TO: Development Review Board
FROM: Scott Gustin 
DATE: November 18, 2014
RE: 15-0549SP; 316-322 Flynn Avenue

Request: Sketch Plan review to remove existing building and construct new mixed use building for deli, office space, and nine residential units.

PINE & FLYNN DEVELOPMENT | SKETCH PLAN REVIEW

Proposed Site Plan

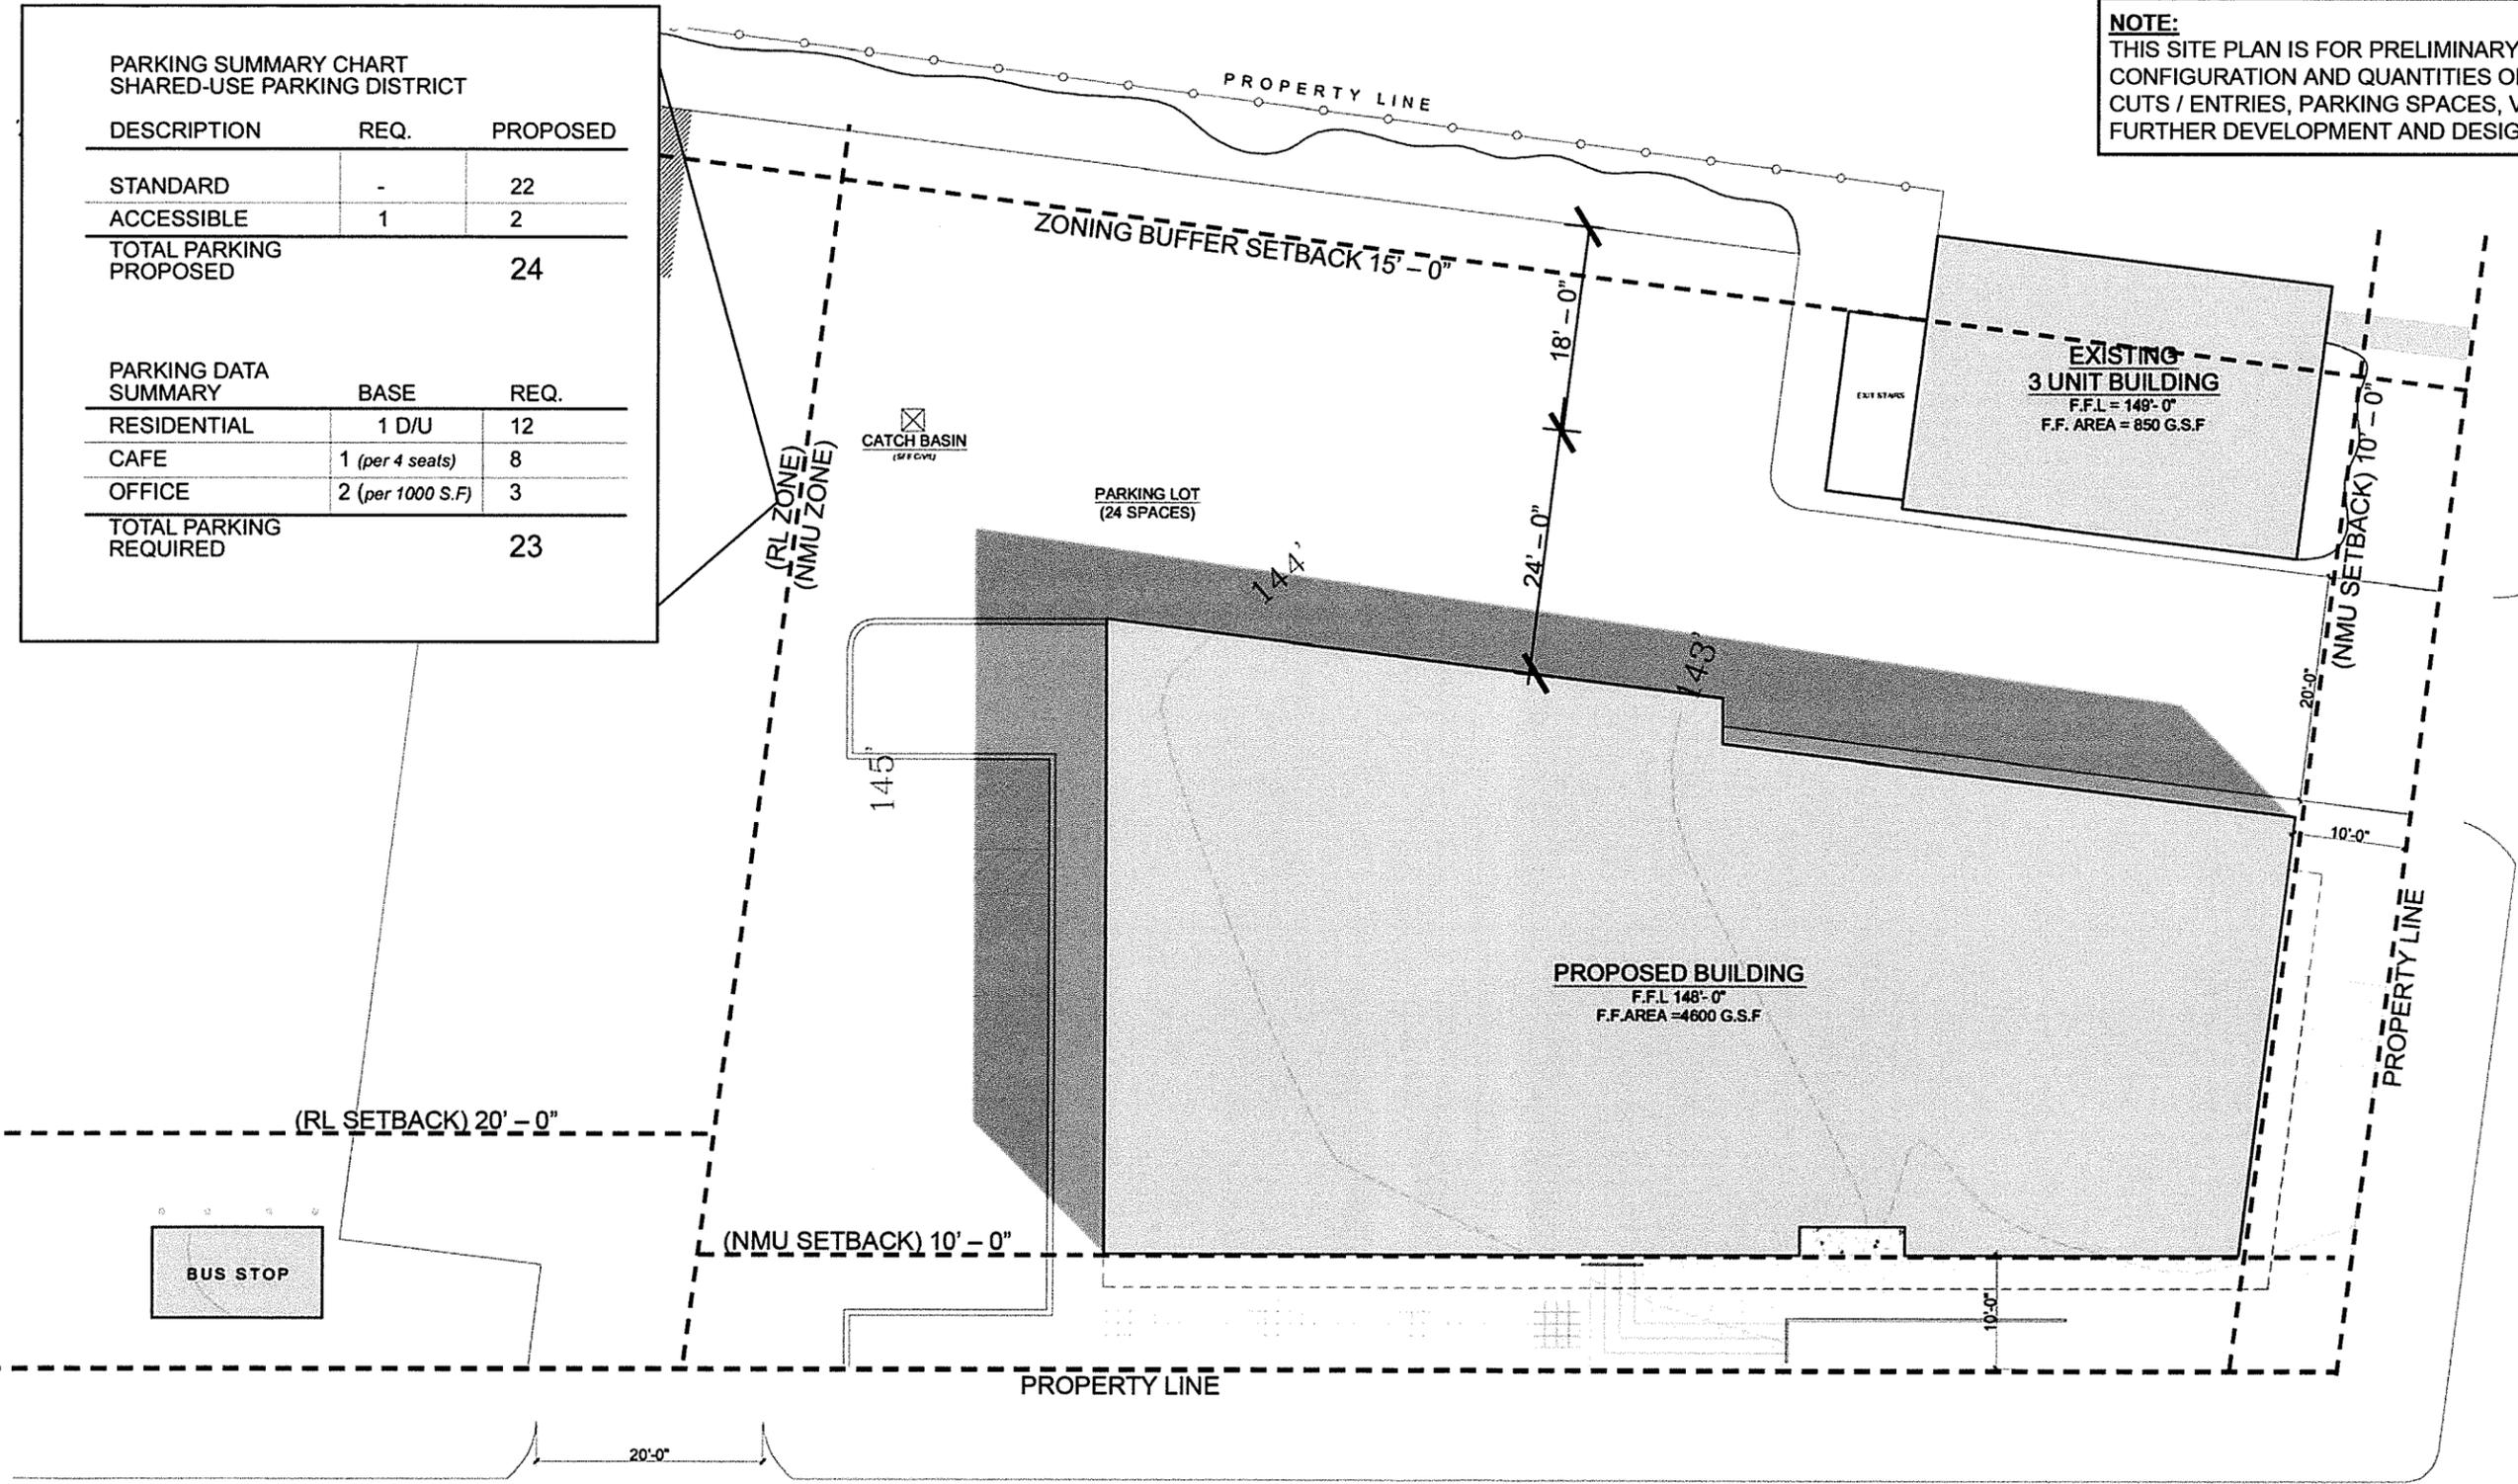
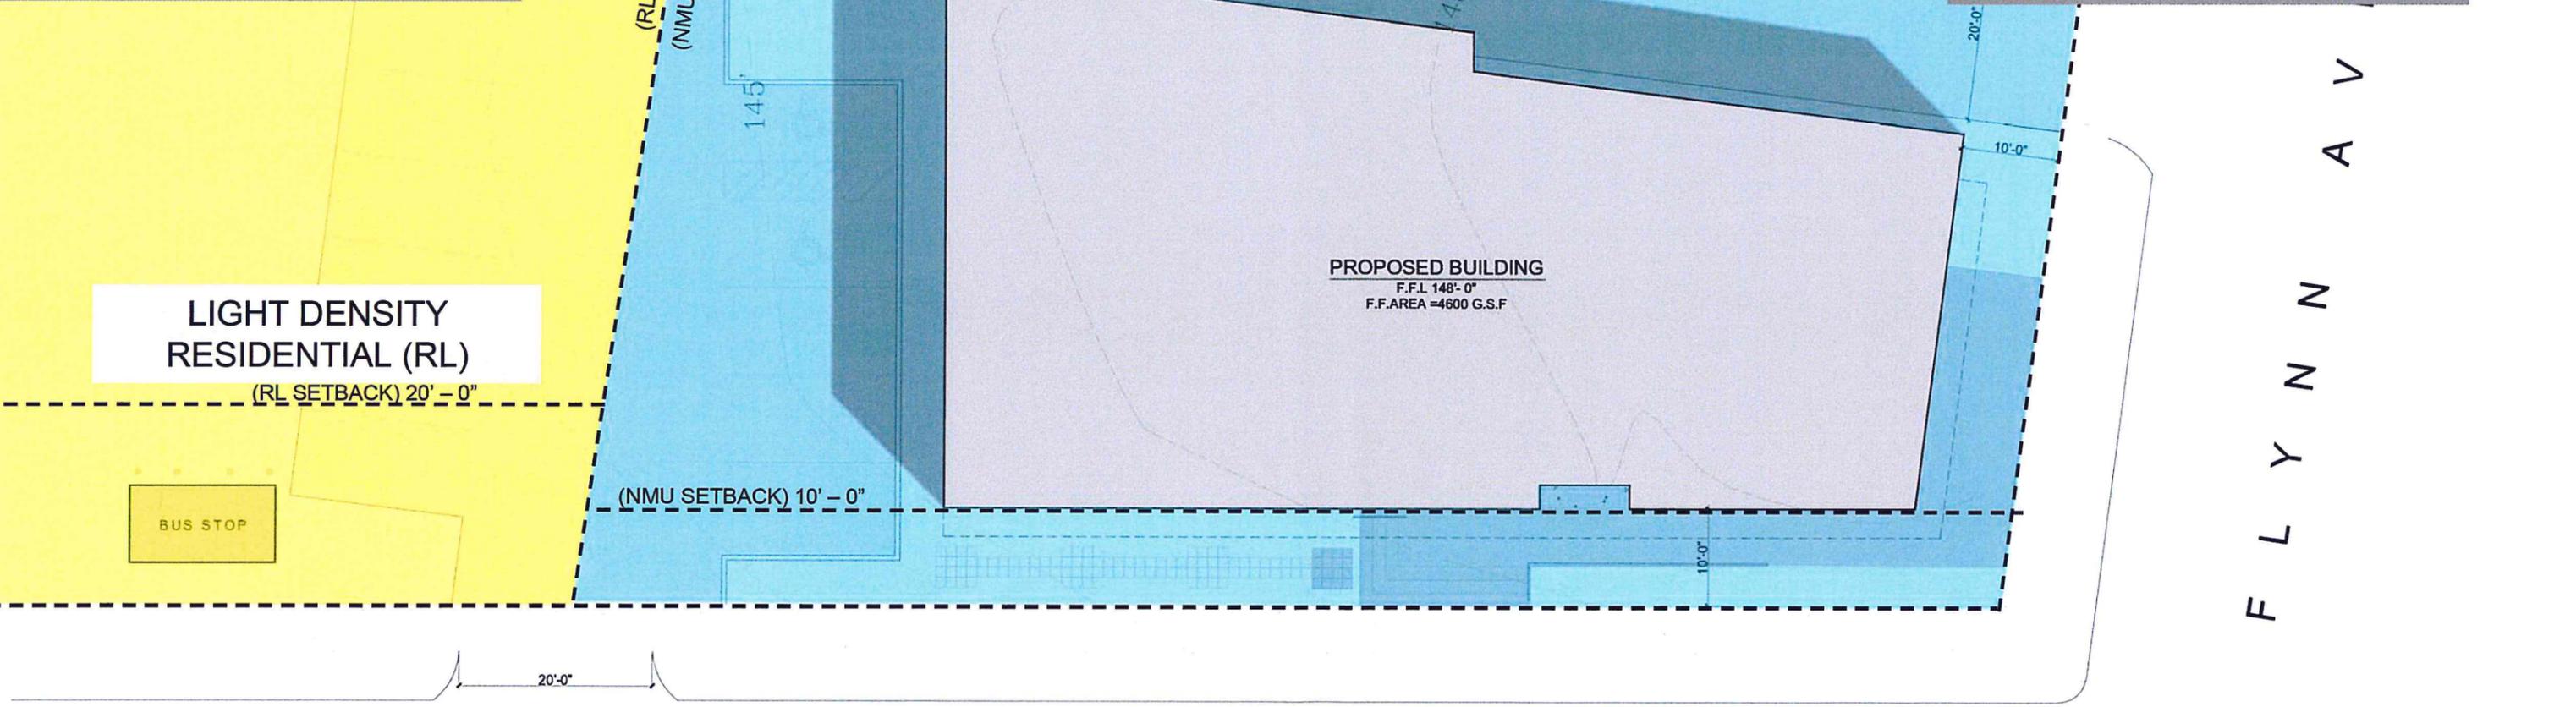
FAR in the NMU zone is limited to 2.0. The subject property is 26,424 sf (with 16,420 sf in the NMU zone). Gross square footage is 19,180 sf or 1.2 FAR relative to the NMU portion of the property. The sketch plan notes a FAR of 0.36 and needs to be corrected for the formal permit application.

Maximum permissible lot coverage is 80% in the NMU zone and 35% in the RL zone. The sketch plans note that coverage in the NMU portion will be 71% and will be 42% in the RL portion; however, the 71% is inaccurate for the NMU portion of the property. The 71% is based on 18,776 sf coverage on the entire property. Coverage within the NMU zone needs to be noted, and it needs to be based on just that portion of the property within the NMU zone. The 42% RL coverage appears to be accurate. Existing coverage in the RL portion is nonconforming at 45%. The reduction to 42% is acceptable.

Reconstructed surface parking is placed to the side and rear of the building. The existing streetfront pavement will be removed and replaced with the new building and associated walkways, stairs, and patio. The rear parking area in particular will be screened by the existing and proposed buildings. Parking spaces are compliant at 9' X 18' within the surface parking lot. Back up space is sufficient at 24'. New landscaping is proposed along the periphery of the parking area, but no shading analysis has been provided. At least 30% shading of the surface parking should be achieved. The new trees along the northern border, while acceptable as landscaping, will provide no shading of the parking lot. The shrubs proposed along the eastern edge of the parking lot should be switched to shade trees in order to achieve the needed shading.

Landscape Plan

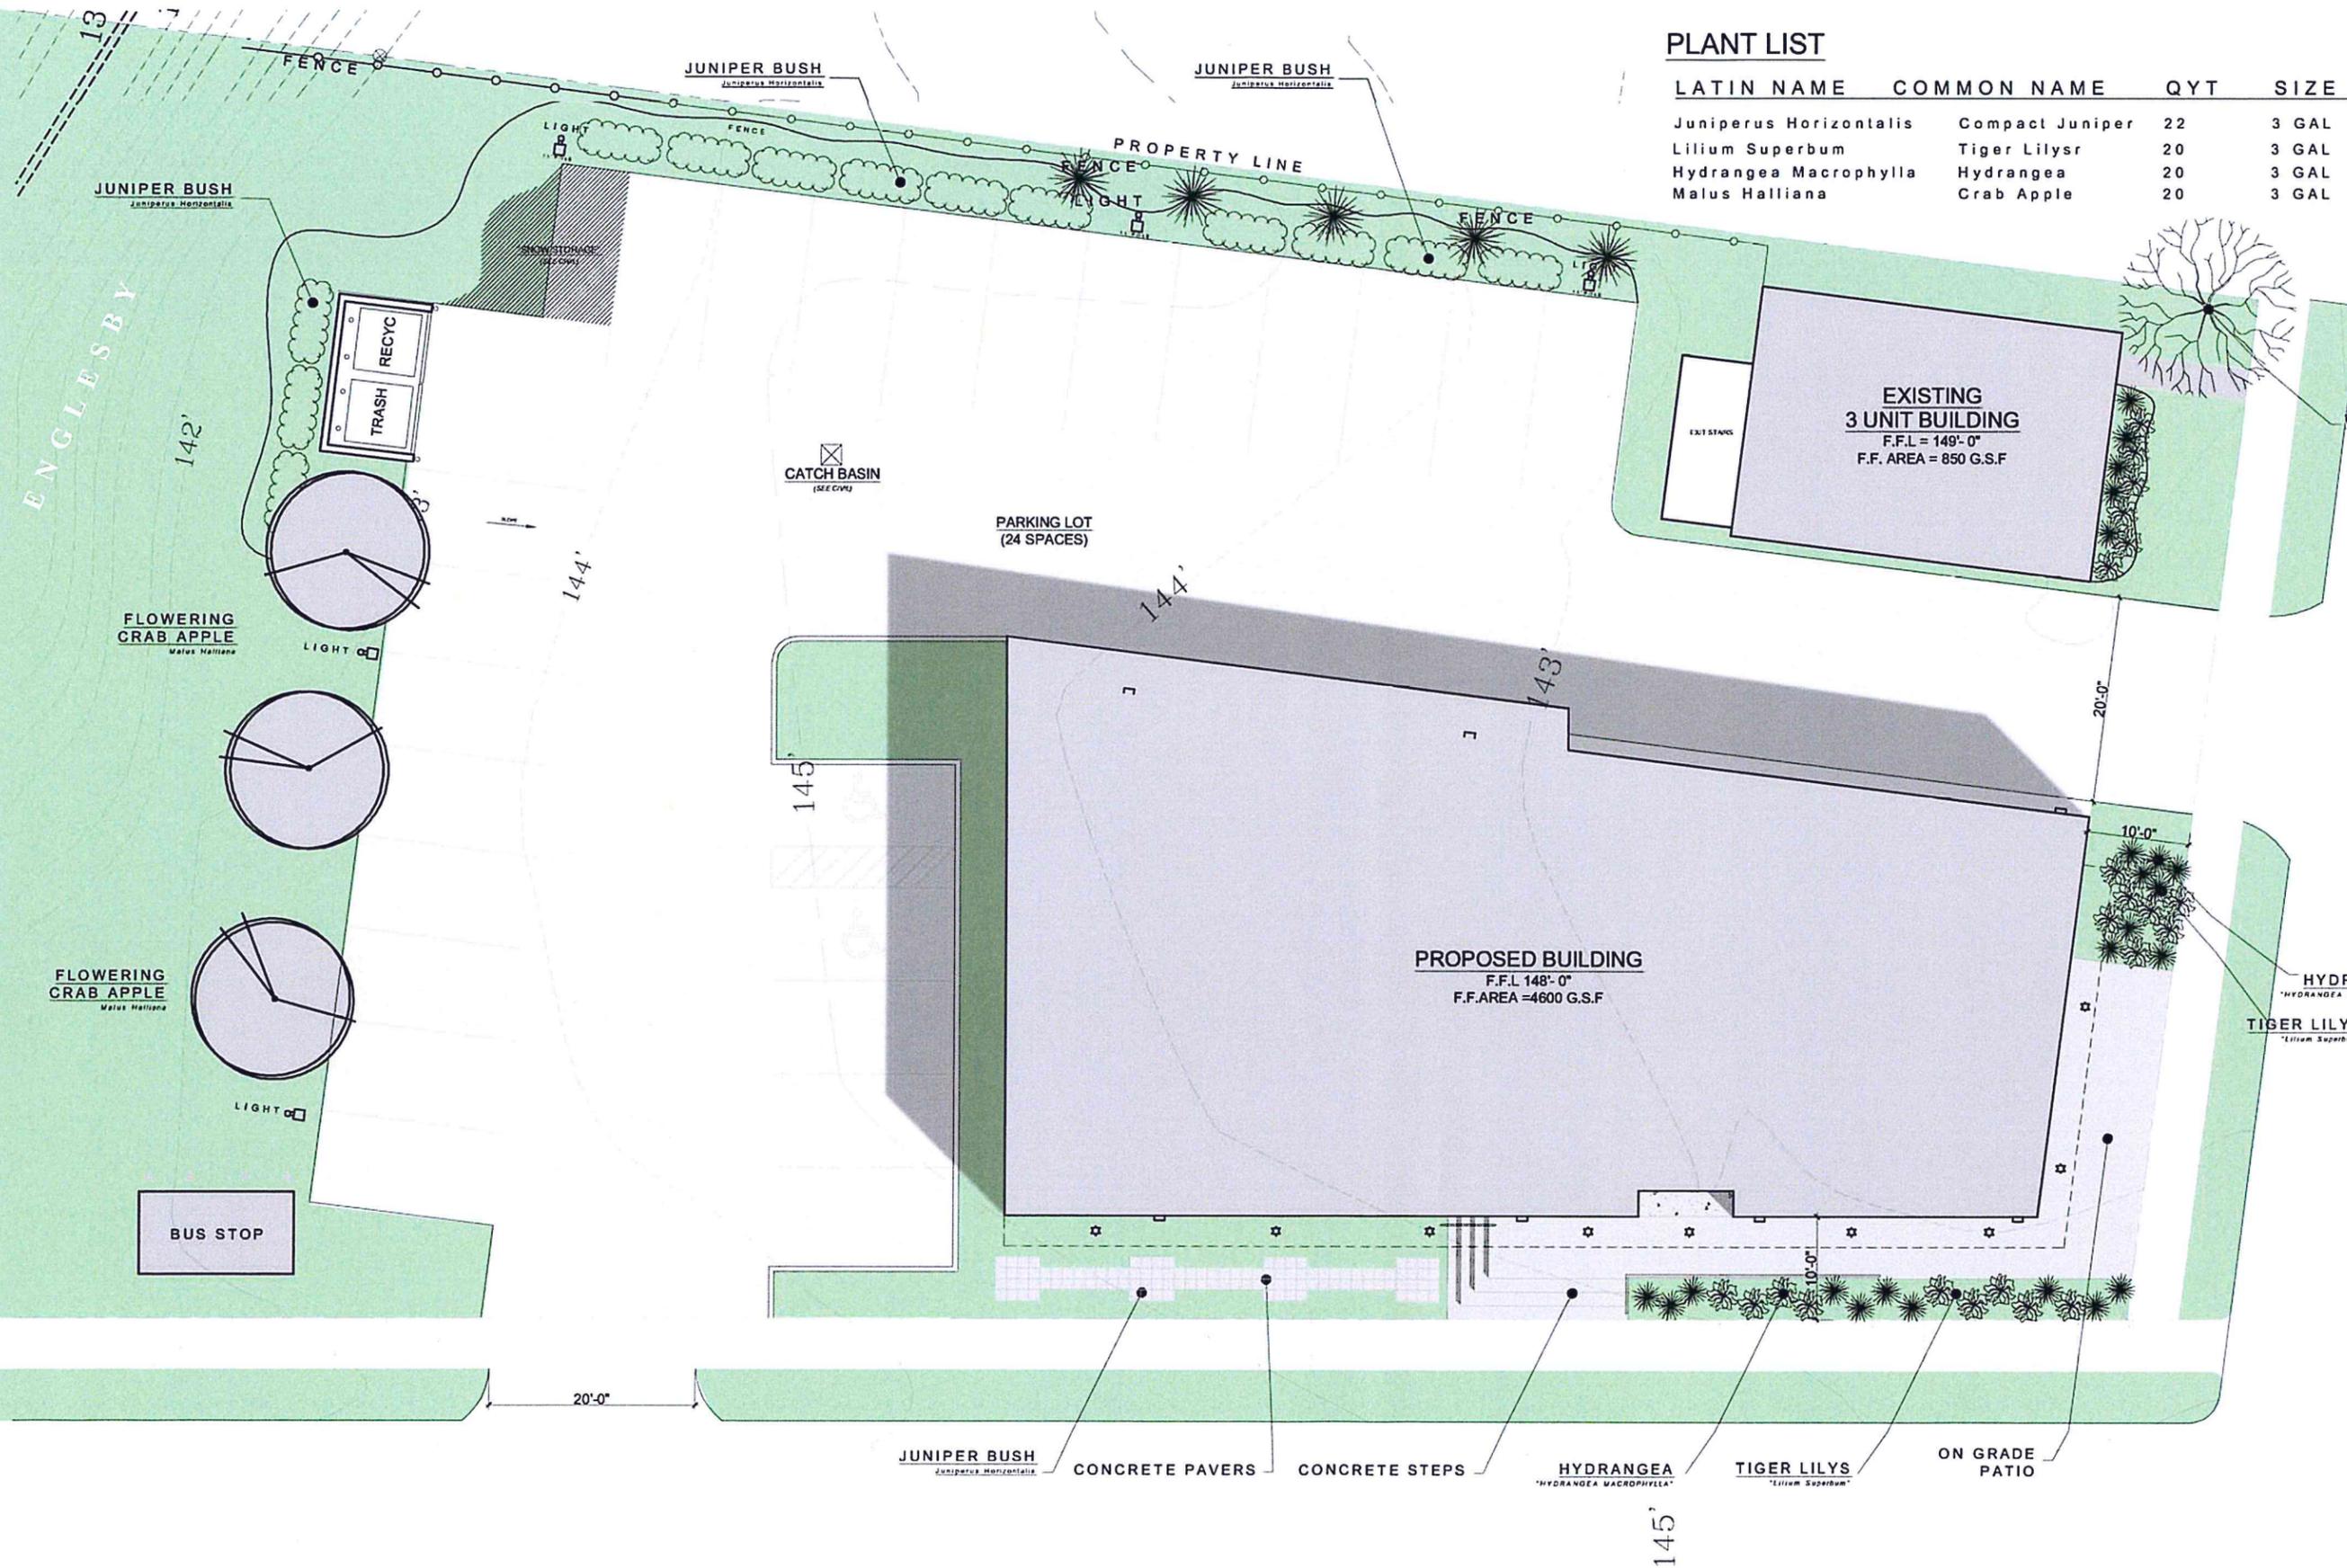
The sketch plans include a proposed landscaping scheme. As noted above, revisions will be needed in order to achieve the necessary parking lot shading. Most of the landscaping consists of hydrangeas and tiger lilies. The plant list notes 20 crab apple trees; however, the plan only depicts 3. Landscaping is concentrated in garden beds in front of the existing and proposed buildings. No new landscaping is proposed in front of the Pine Street parking lot. New landscaping, particularly trees and shrubs, should be installed here to screen the parking lot from the street.
